UDRP Comments Graphic Response Cont.

LOC2020-041 Midfield Heights Urban Design Pre-Application Comments Graphic Response – Detailed Team Review 1 Comment 10

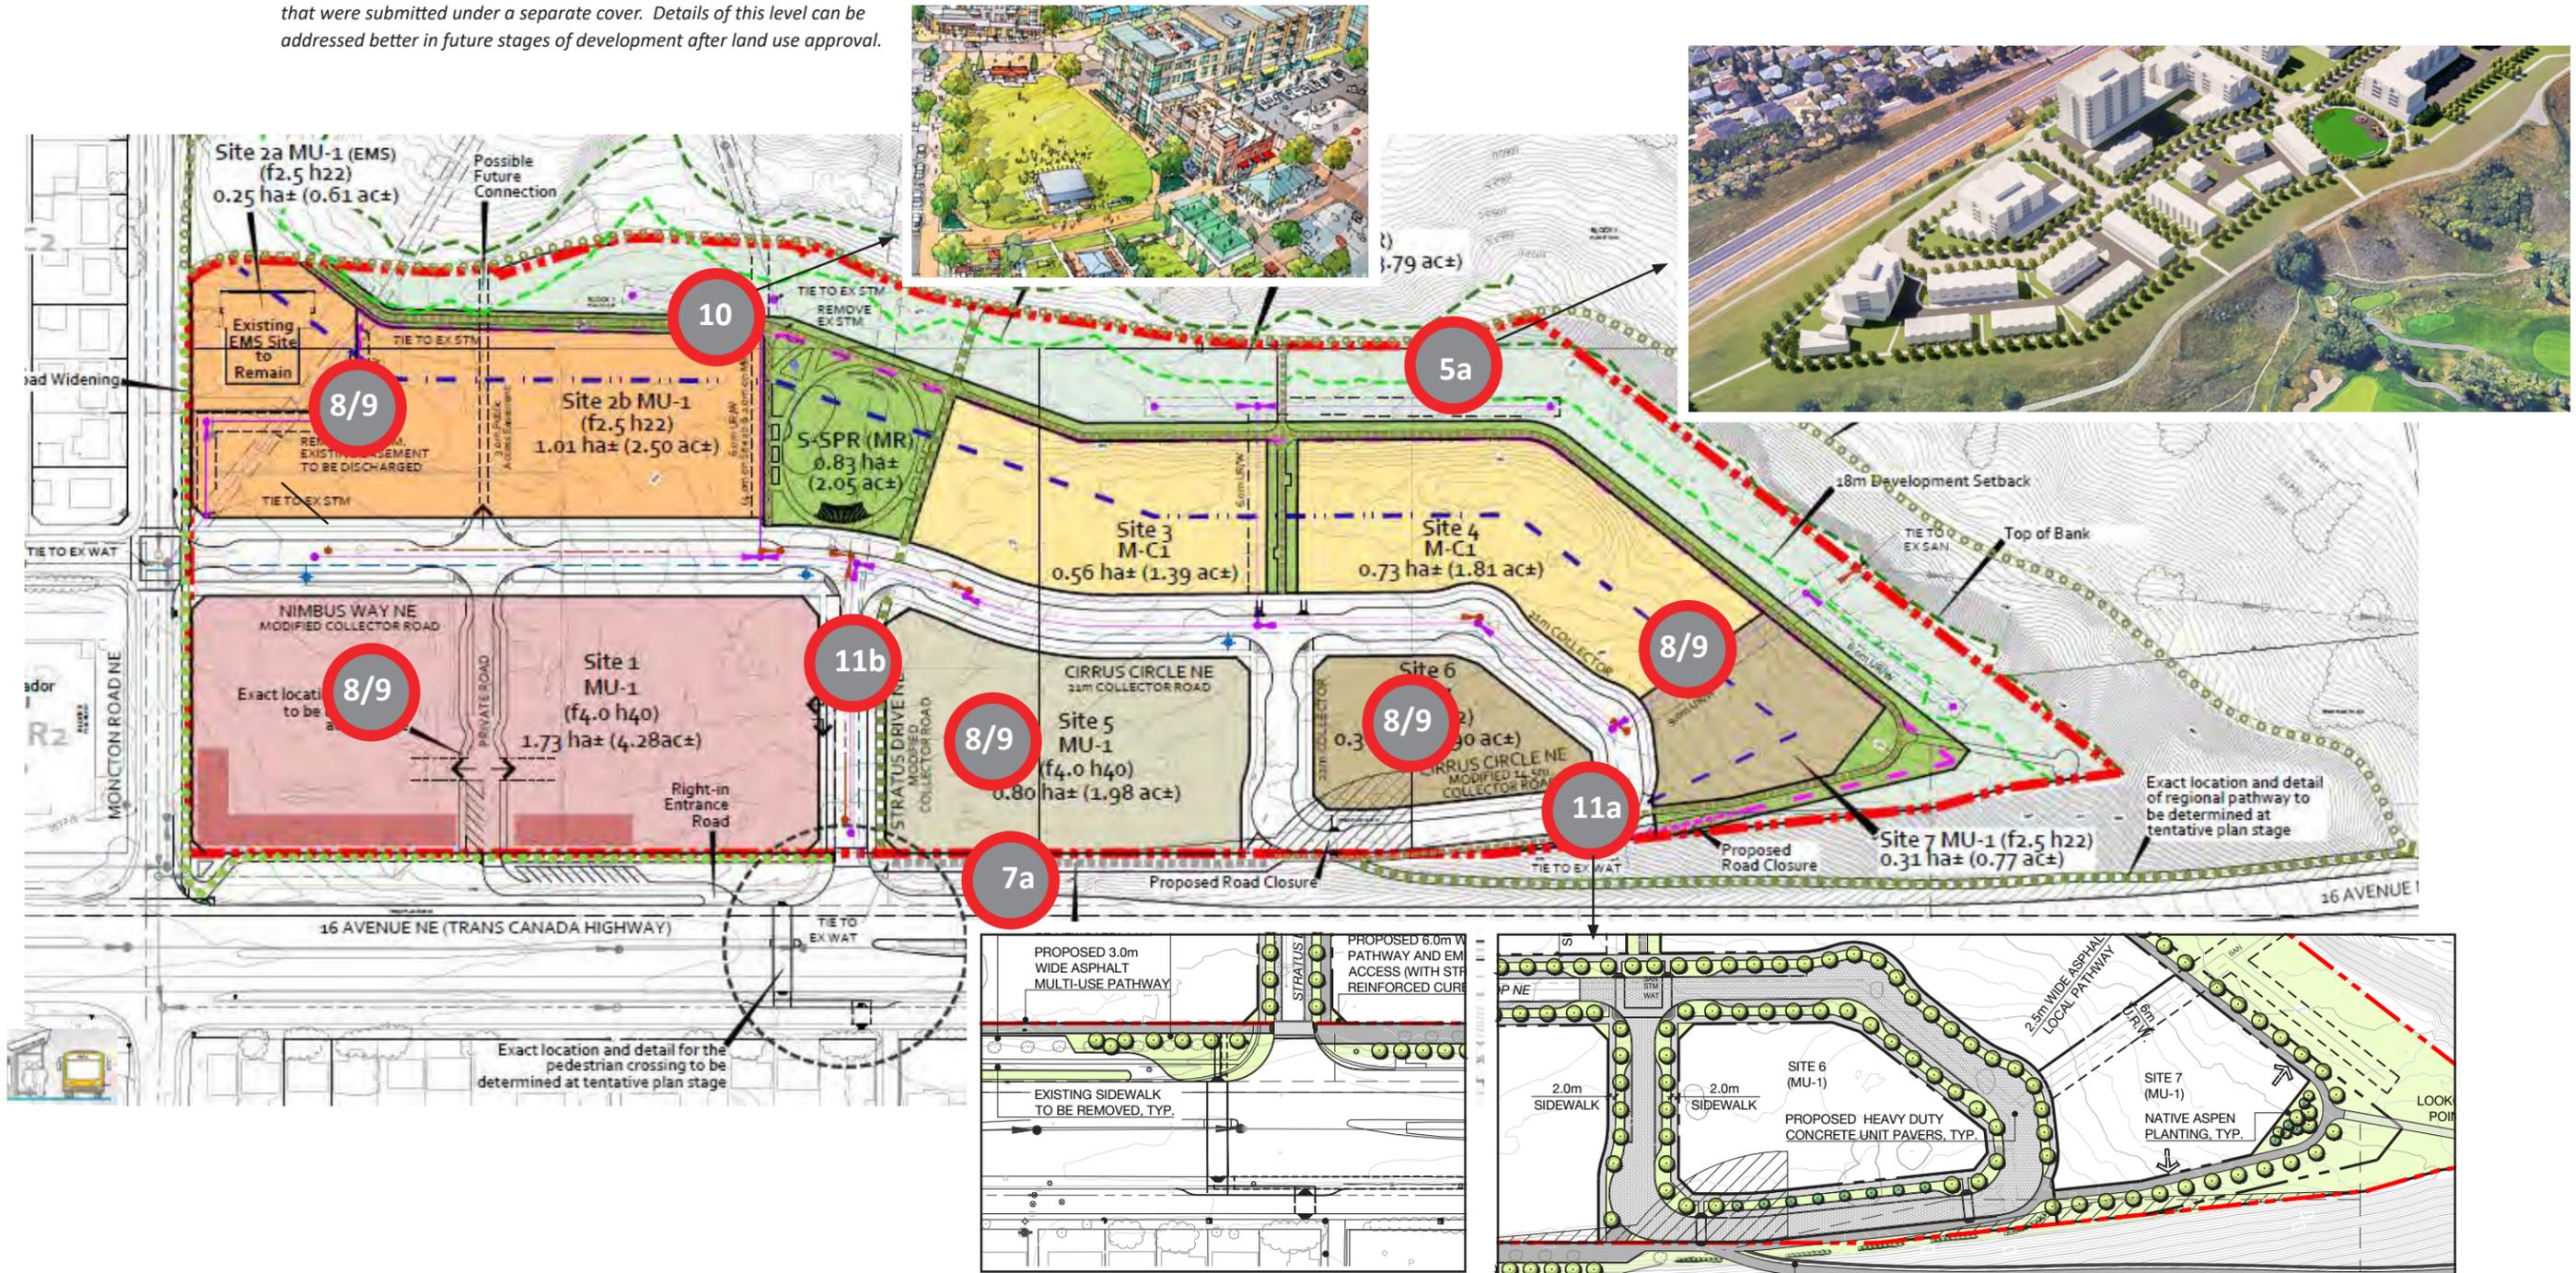
5. Connectivity

7 & 10. Accessibility and Safety

8 & 9. Diversity and Flexibility

11. Orientation

13. Durability

Park connections and public access have been enhanced through local pathways adjacent to Site 3 and 4. It is anticipated that all development will orient towards and address the escarpment and open space (5a). Connections to the existing regional pathway are proposed from within the site plus an upgraded pathway on Moncton Road. Pedestrian improvements such as enhanced crosswalks, tree lined boulevards and 'pedestrian priority streets' all serve to focus on a pedestrian-first design. As per Parks' requirement, the ER will be restored with natural flora/fauna. A strip of MR is proposed as transition zone to accommodate the upper pathway for connectivity.

Pathways and open space have been designed to be barrier free. The stairs that were proposed connecting to eastern Point Park have been removed. Accessible pedestrian crossing across 16 Avenue/Stratus Drive is proposed (7a) and will be studied further. Public sidewalks, local pathways and frontage onto the open space promote active frontages and 'eyes on the street /park' (10). Pedestrian priority streets promote slower vehicle movements and enhance safety for pedestrians and cyclists.

In response to UDRP comments, the legibility of street network is enhanced through the distinct treatment of cross walks and pedestrian priority streets at the eastern end of Cirrus Circle (11a). The termination of north-south streets have been aligned with parks to the vistas beyond to ensure viable visual connections (11b). Architectural forms are to be street-oriented and aligned with the Design Guidelines. The introduction of MU-1 Site 7 creates the opportunity for an iconic structure at the southeastern tip identified as the gateway.

Exploration of landscaping and paving materials is underway for Nimbus Way and Cirrus Circle. The Design Guidelines will also help promote durability and resilience.
